**Town of Surfside  
PLANNING & ZONING BOARD  
AGENDA**

**August 27, 2020 – 6:00 p.m.**  
Town Hall Commission Chambers –  
9293 Harding Ave, 2<sup>nd</sup> Floor, Surfside, FL 33154

5. **Applications:**
  - A. **9516 Bay Drive – New Single Family Residence**
  - B. **9556 Carlyle Avenue - New Single Family Residence**
  - C. **8955 Collins Avenue – Monument Sign**

Sheet:  
**A4**  
 4 of 15

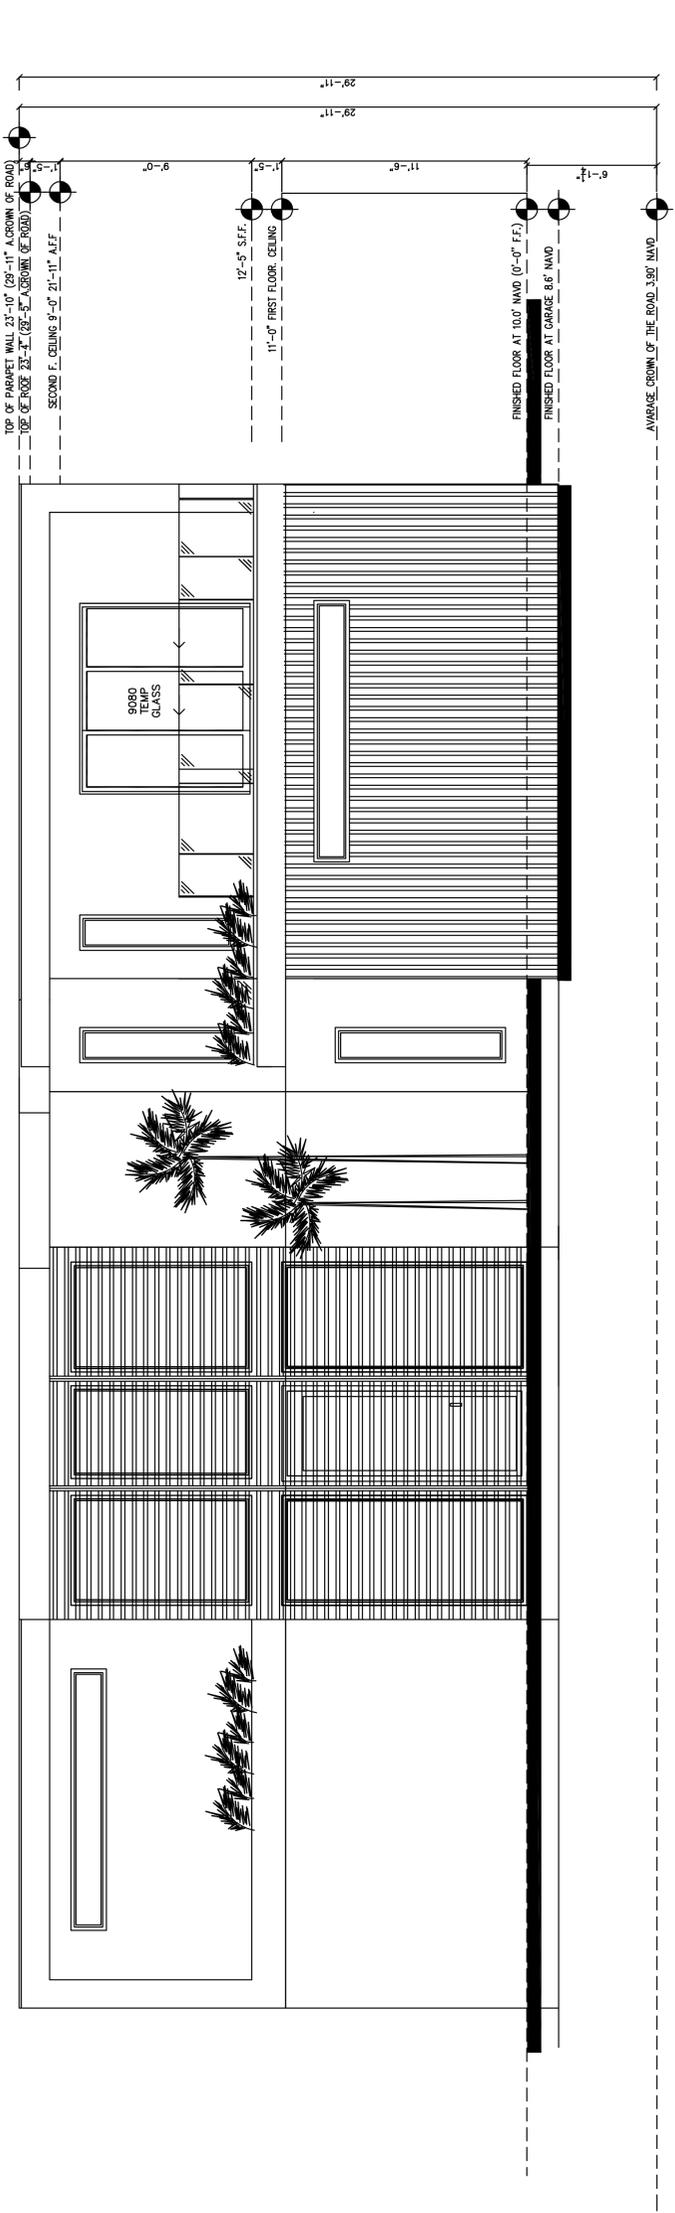
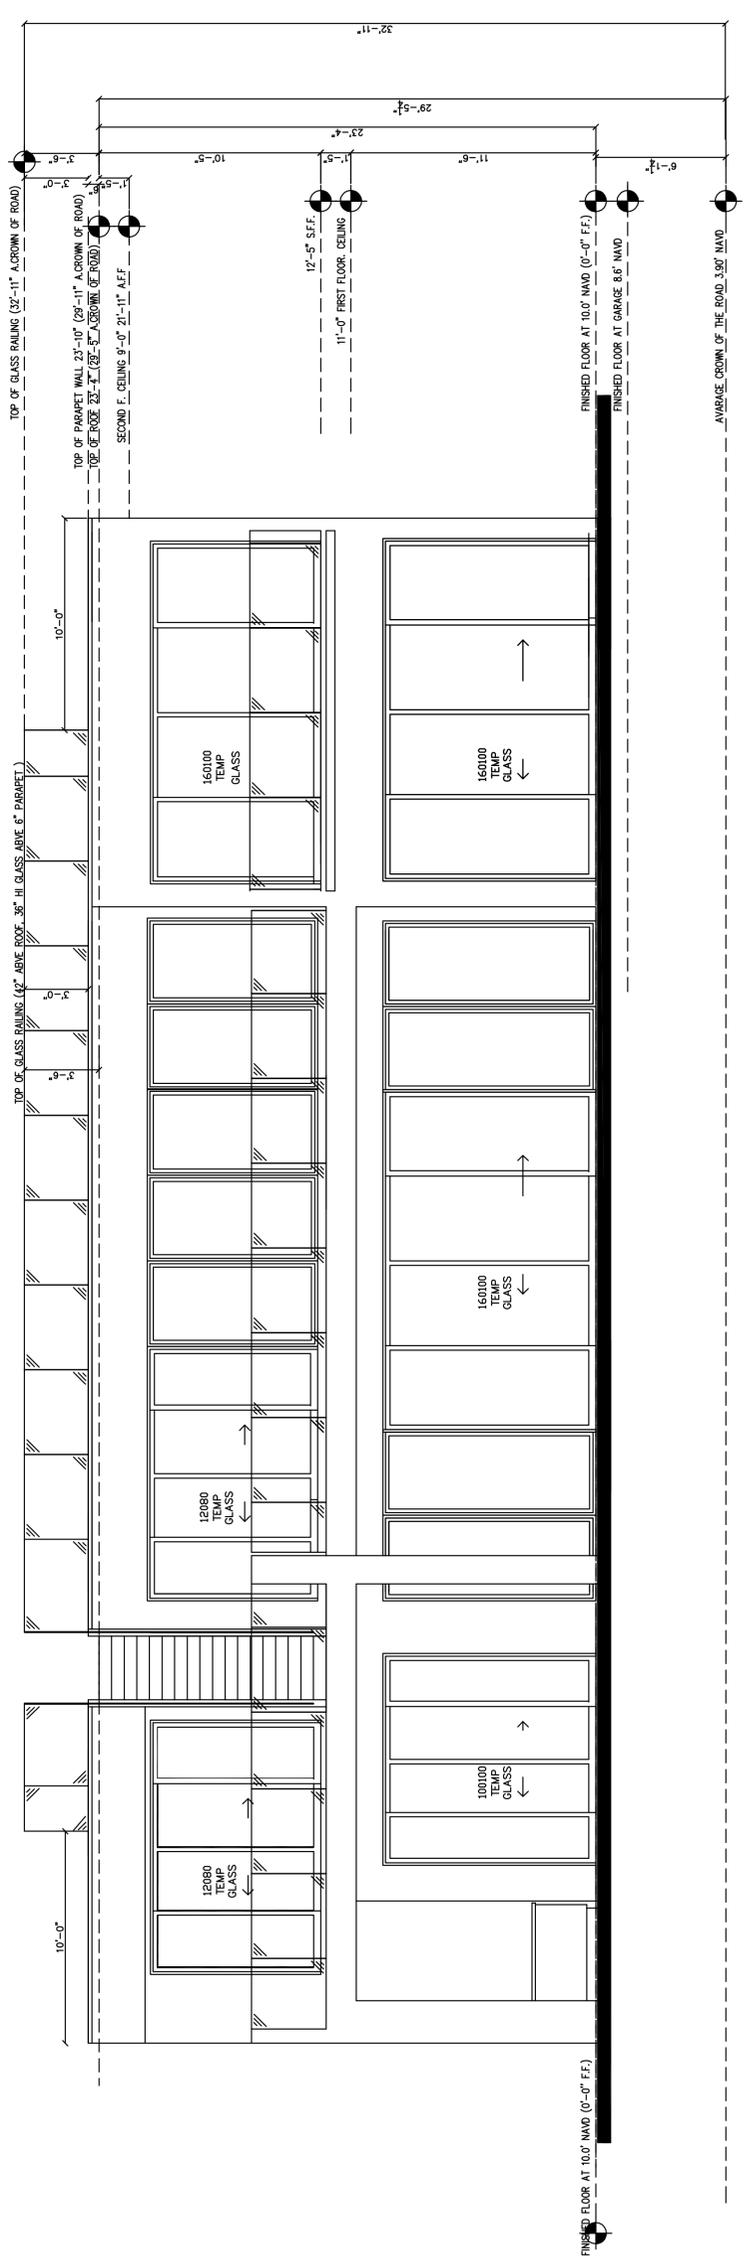
- 2) Provide the projection distance for the eyebrows on the north and south elevation. Such architectural elements cannot project into the setback more than 24" per Sec 90-47.
- 3) Provide dimensions and overall calculations for required and provided front and rear yard landscaping areas to determine consistency with Sec 90-194 of the 2006 Code.

Sheet:  
**CV2**  
 4 of 15

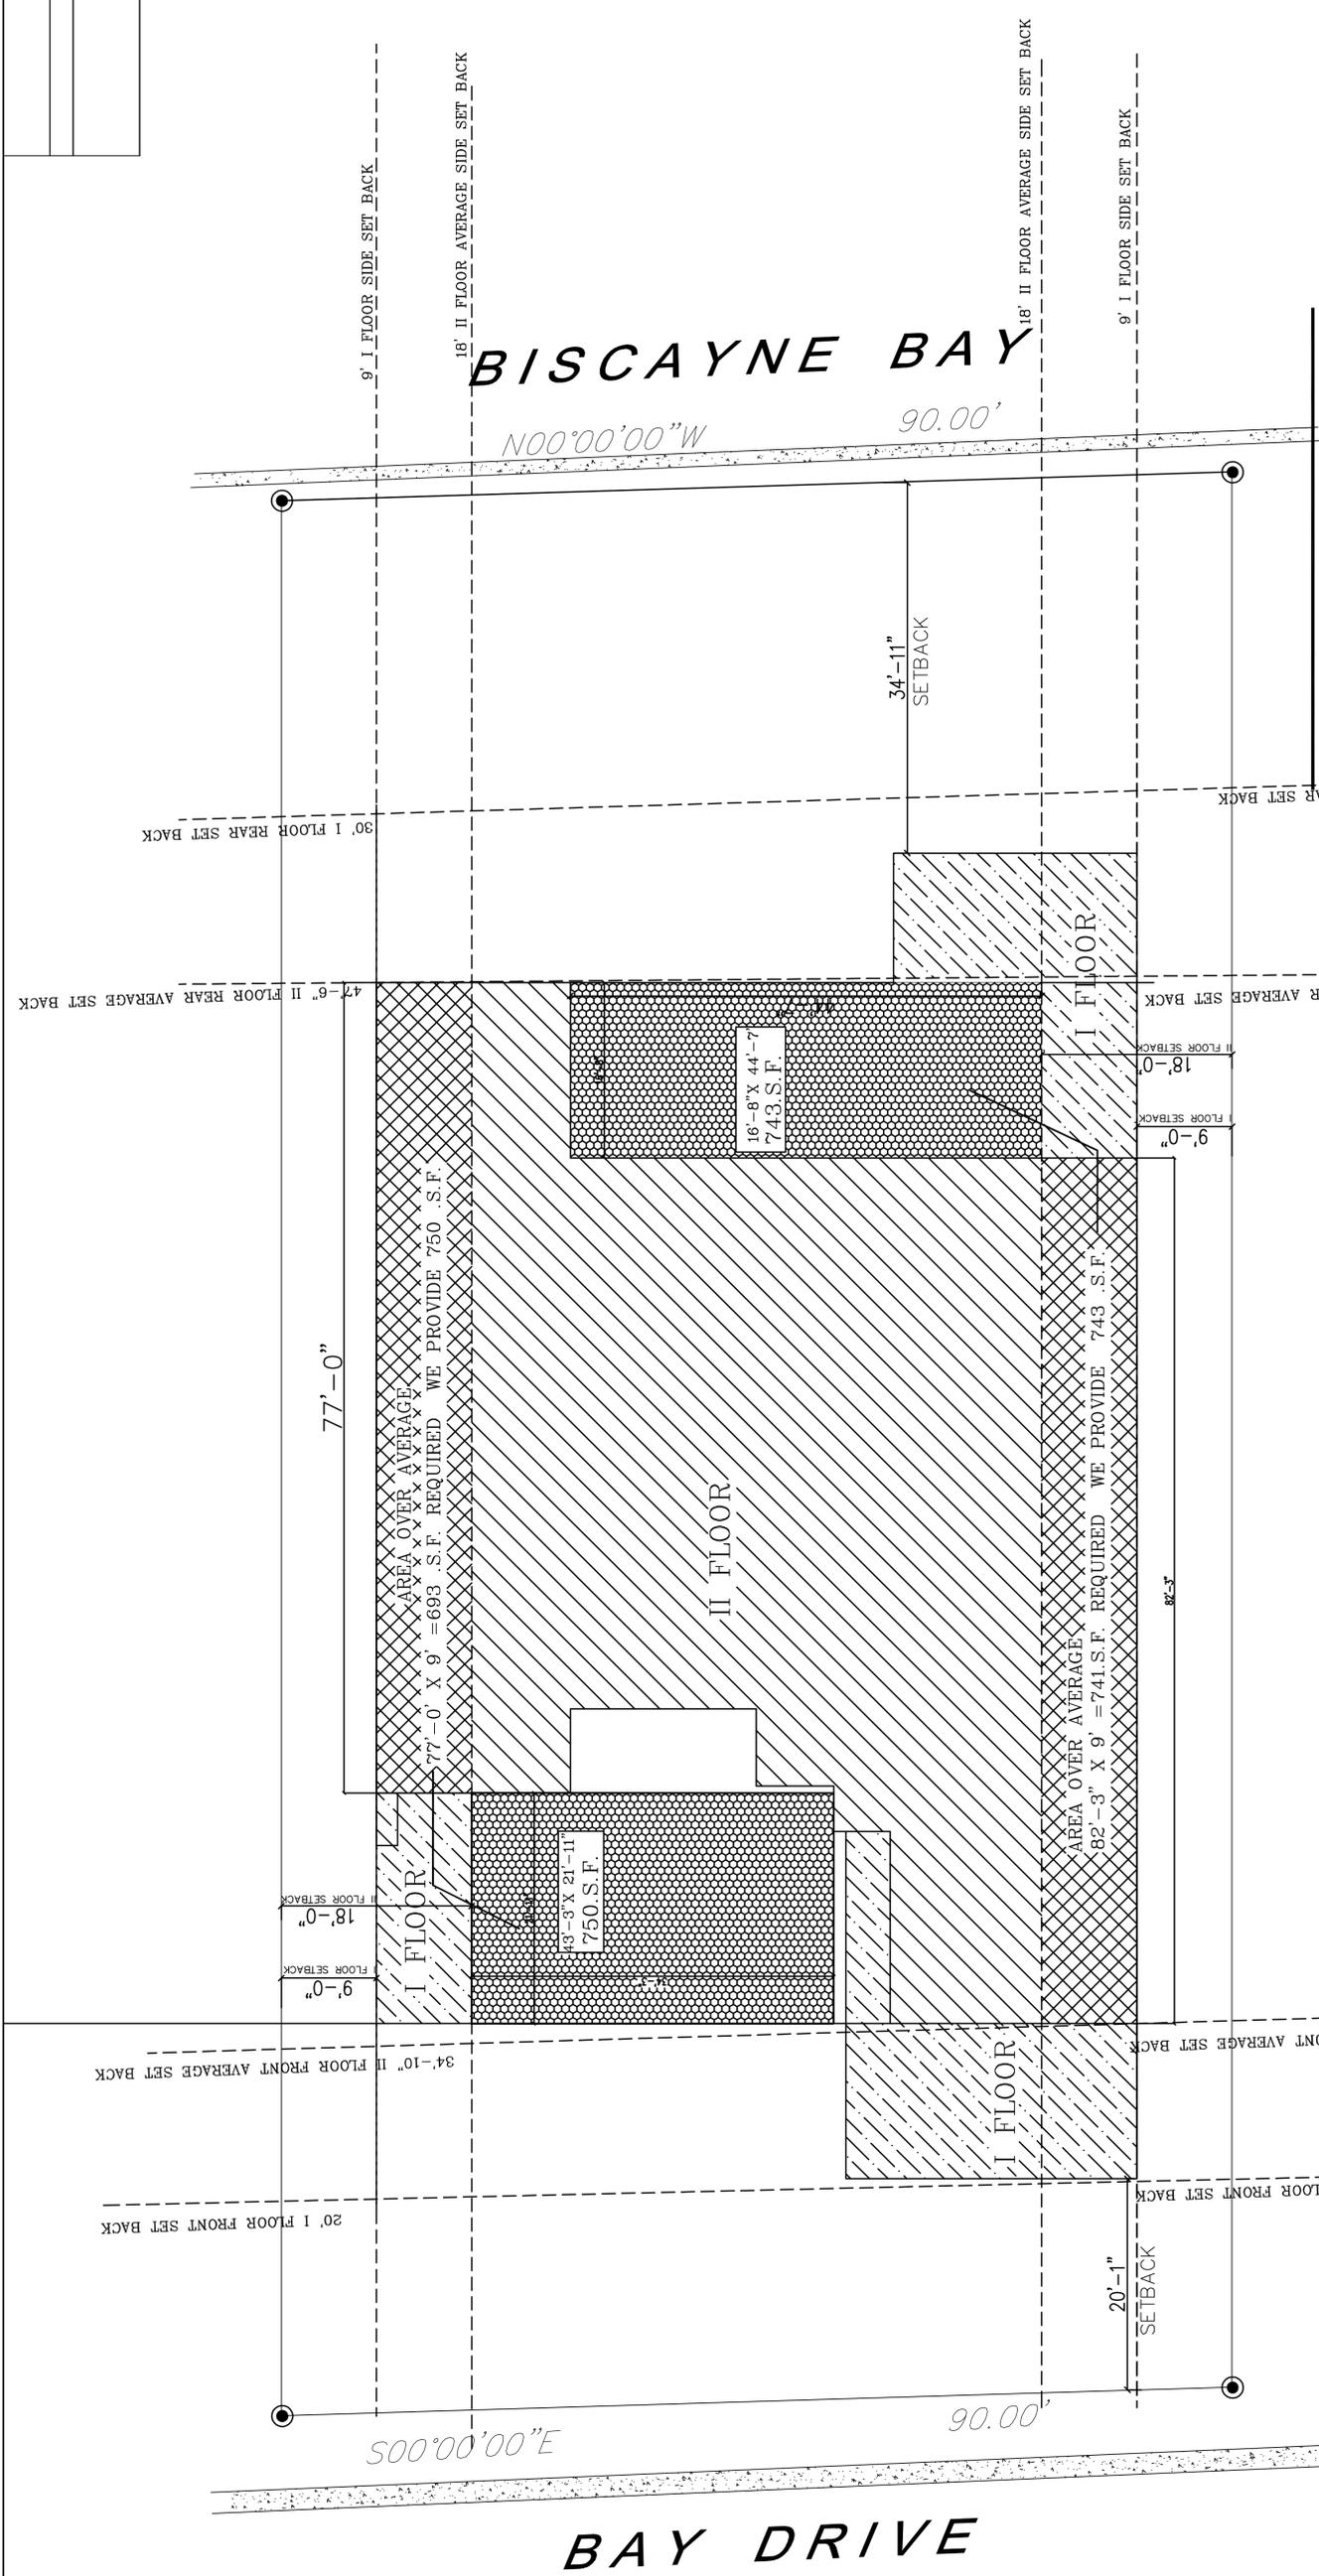
between sheet CV2/A2 and CV3 as it relates to the 2<sup>nd</sup> floor coverage – specifically the average upper story front setback. CV2/A2 shows the second floor extending to the first-floor wall plane – creating a scenario portraying an average 20’ upper story setback. The required upper story average front setback is 30’ – as shown on CV3. Please update sheet CV2/A2 to reflect and provide consistency with other sheets. Furthermore, A4 appears to show a flush wall plane between the two stories. It doesn’t appear that the second-floor steps back.
